RE: Norfolk Southern Pittsburgh Vertical Clearance Project (the Railroad Project), Determination of Effects Report (December 2022; Effects Report) prepared for Norfolk Southern Railway Company, by Michael Baker International, Inc

Determination of Effects Report (December 2022) Response

RE: ER Project # 2018PR13984.021, NORFOLK SOUTHERN PITTSBURGH VERTICAL CLEARANCE,
Department of Transportation (PennDOT), Pittsburgh City, Allegheny County

**Map 2: Alternate 2A
Switchback Ramp**

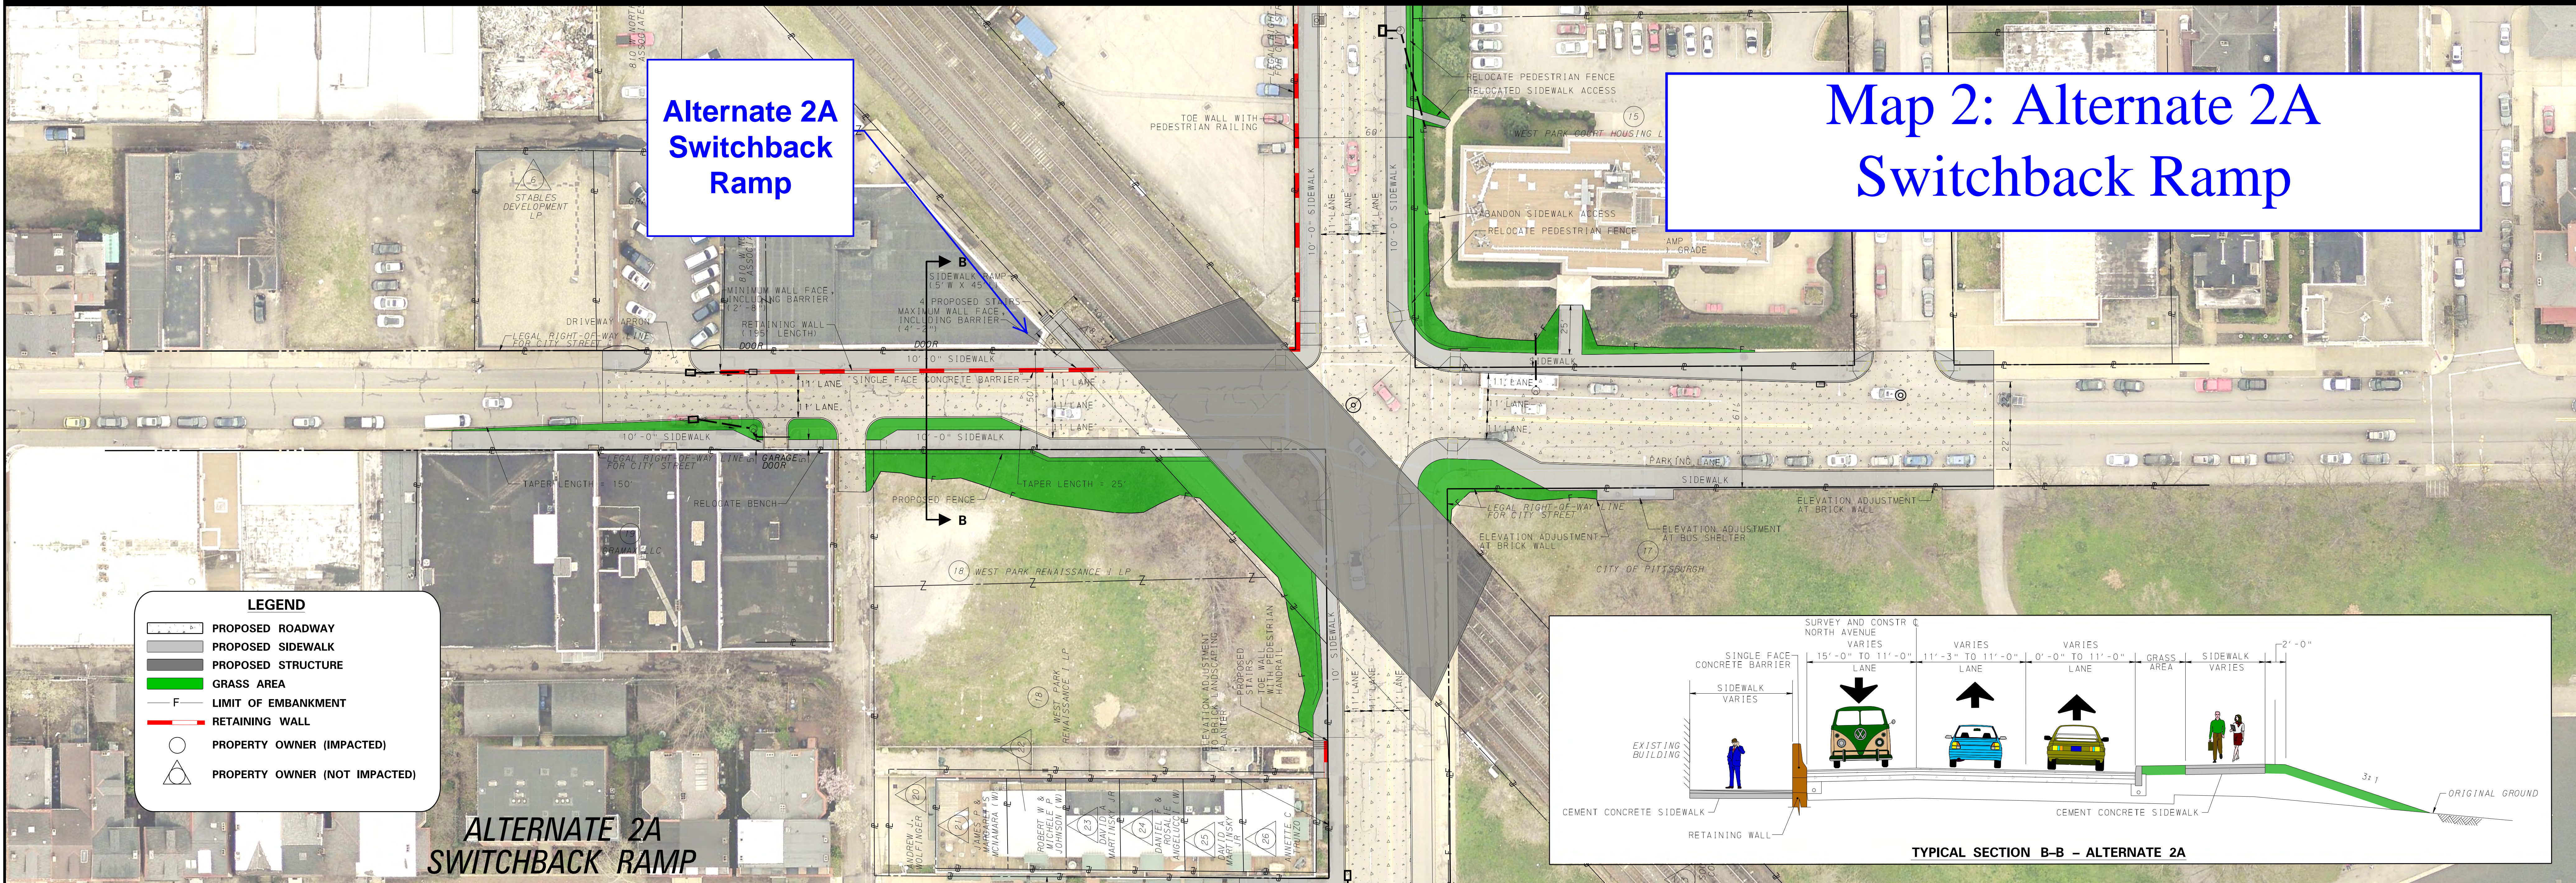
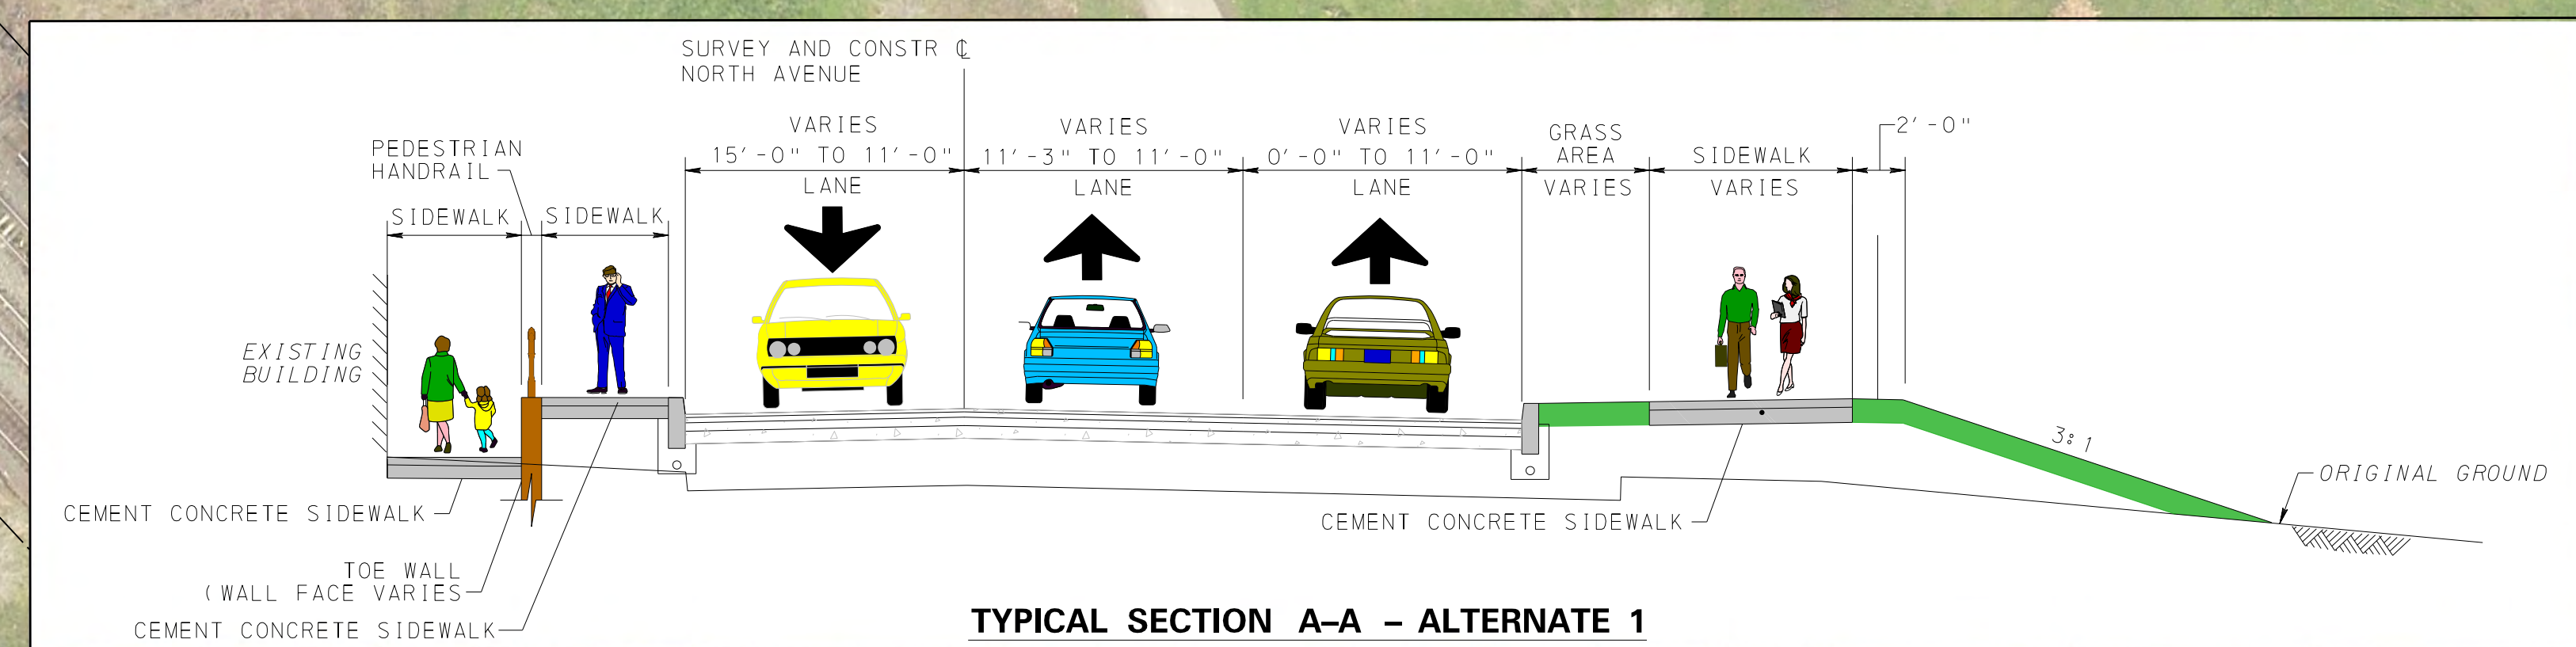
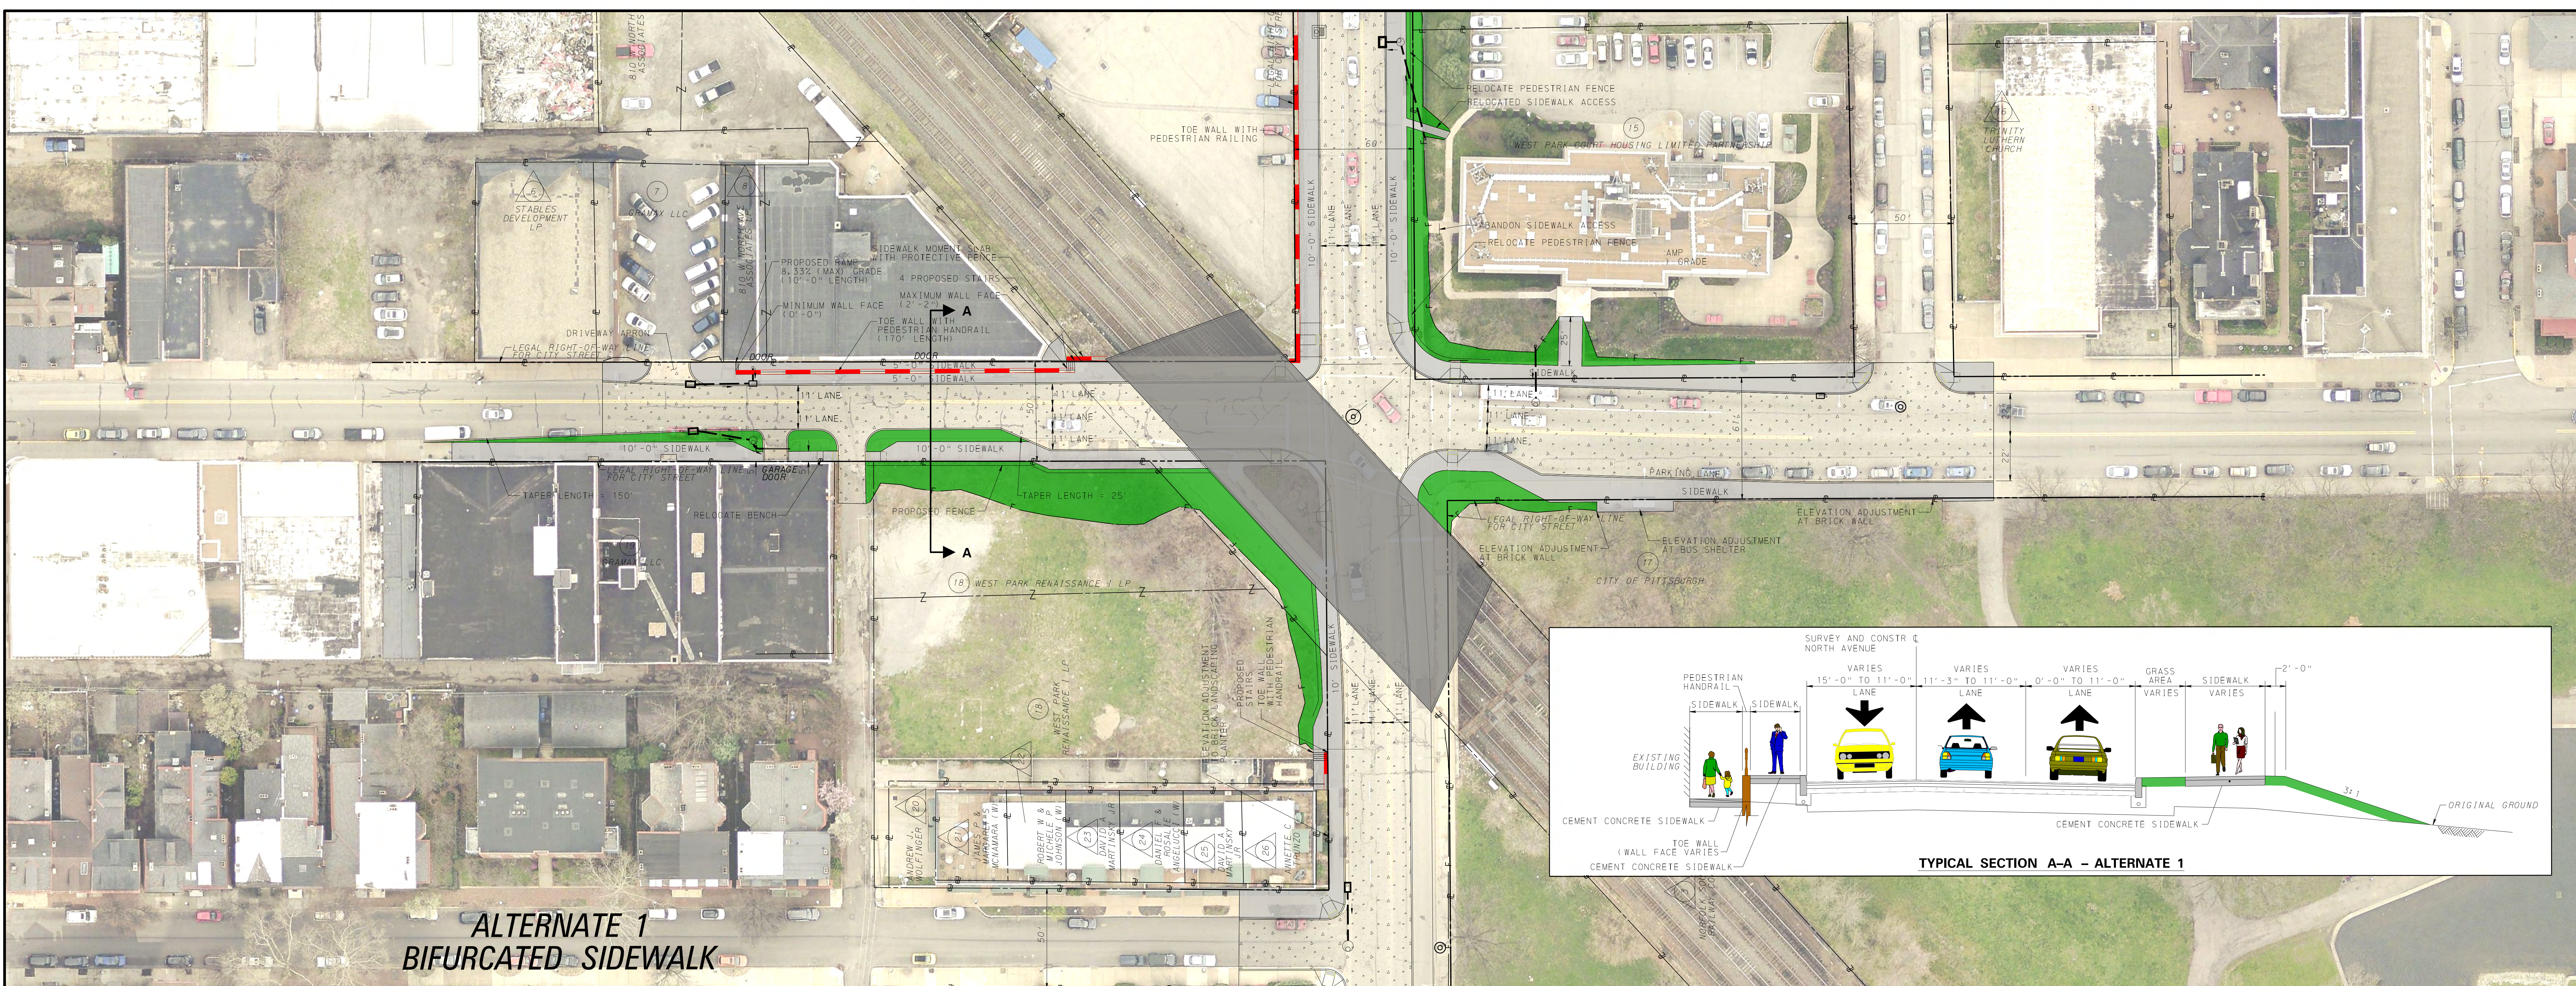
The June 26, 2018 Open House presented alternative considerations to the Preferred Alternative regarding sidewalk and roadway configurations. These sidewalk configurations have the greatest minimization of Adverse Effects to the International Harvester building and are easily resolved. “Alternate 2A Switchback Ramp” is the most successful in resolving many of the Adverse Effects (Map 2, attached).

Rendering 1: Alternate 2A Refined

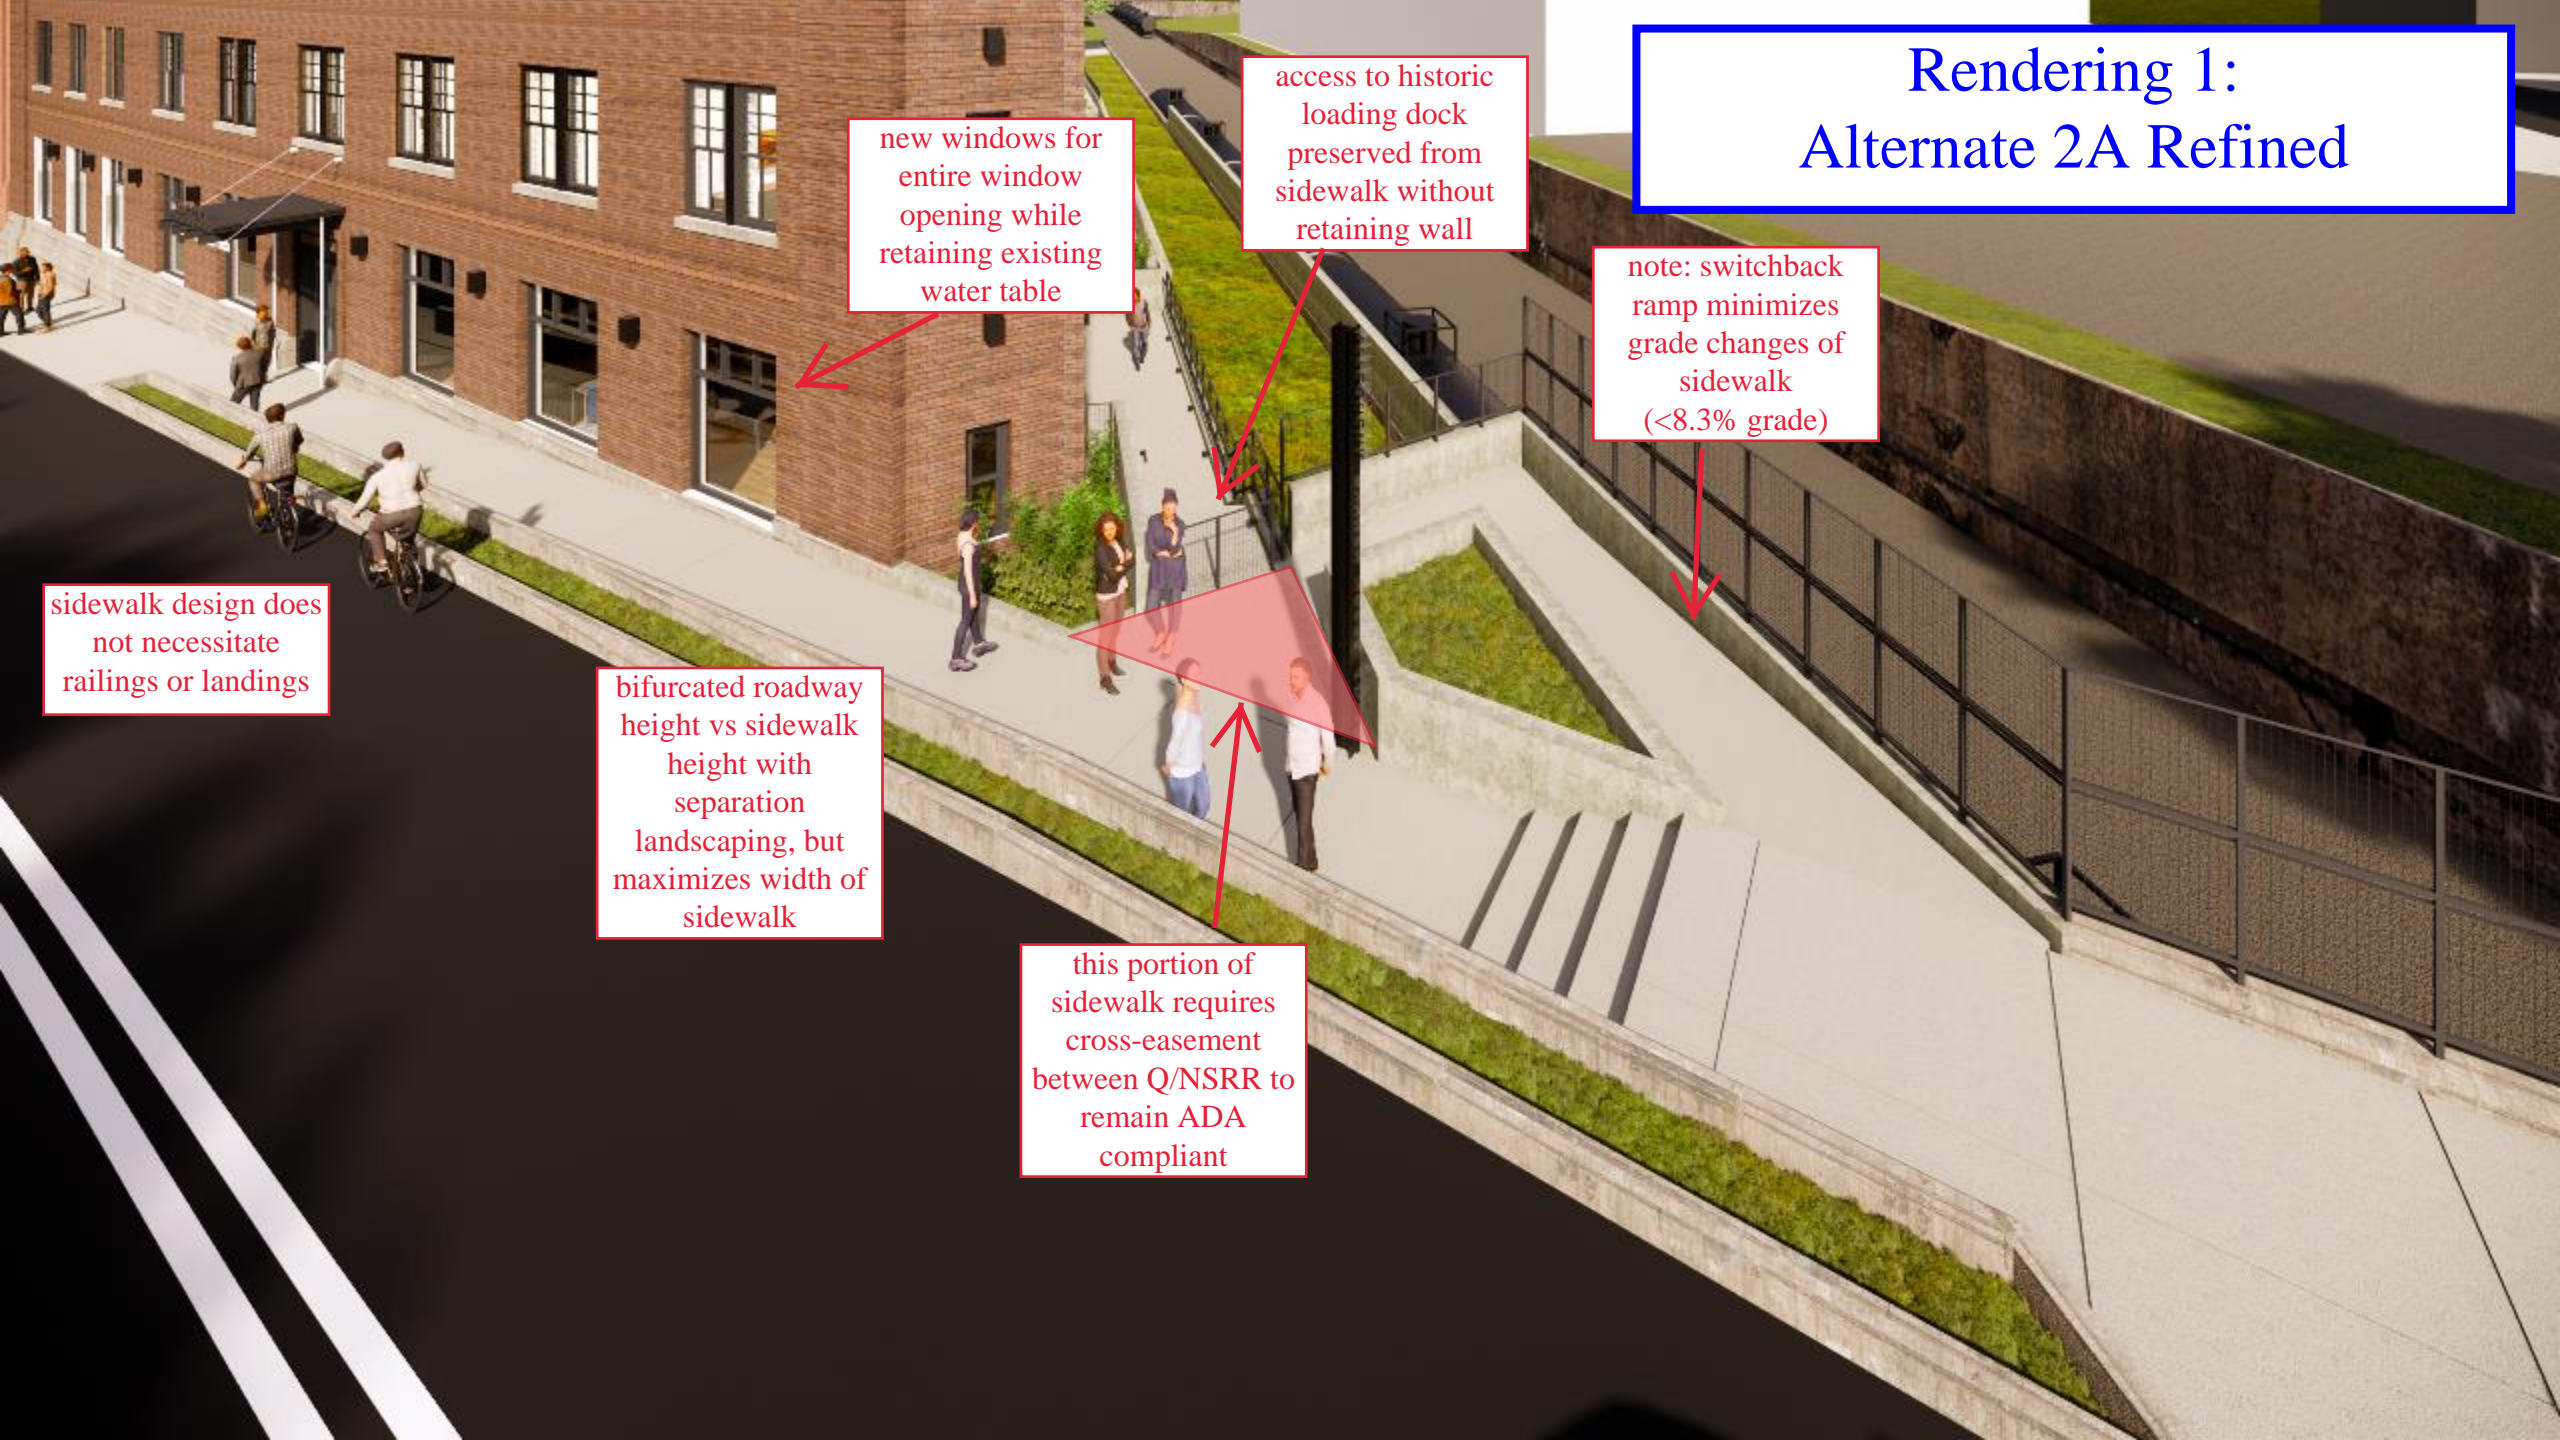
The Q Development team has reviewed Alternate 2A and has proposed modifications to further minimize the potential Adverse Effects (Rendering 1 and Diagram 3 attached). These refinements accomplish:

- ❖ Minimize grade changes along the sidewalk separate from the roadway
 - ❖ Separating the sidewalk and the roadway remains consistent with Alternate 2A and the Preferred Alternative;

- ❖ Provide ADA accessibility via the switchback ramp with slope reduced from three 8.3% sections to one 8.1% and one 7.7% sections;
- ❖ The switchback ramp allows the balance of the sidewalk plan to fit within the 95’ sidewalk distance to the front door, contrary to the Preferred Alternative;

- ❖ Extensive railings on both sides of the sidewalk are unnecessary, and don’t reduce the sidewalk width or have a negative visual impact to the historic property;

- ❖ Access to the historic loading dock/front lobby entry is preserved in an acceptable manner;
- ❖ No further adjustment to the water table is required;

- ❖ No reduction in window opening size is required, preserving both the exterior and interior experience of the historic display window openings;
- ❖ Most important, this approach likely preserves the viability of the \$2.5 million in Rehabilitation Investment Tax Credits approved by the National Park Service on August 9, 2022.

new windows for entire window opening while retaining existing water table

access to historic loading dock preserved from sidewalk without retaining wall

note: switchback ramp minimizes grade changes of sidewalk (<8.3% grade)

sidewalk design does not necessitate railings or landings

bifurcated roadway height vs sidewalk height with separation landscaping, but maximizes width of sidewalk

this portion of sidewalk requires cross-easement between Q/NSRR to remain ADA compliant
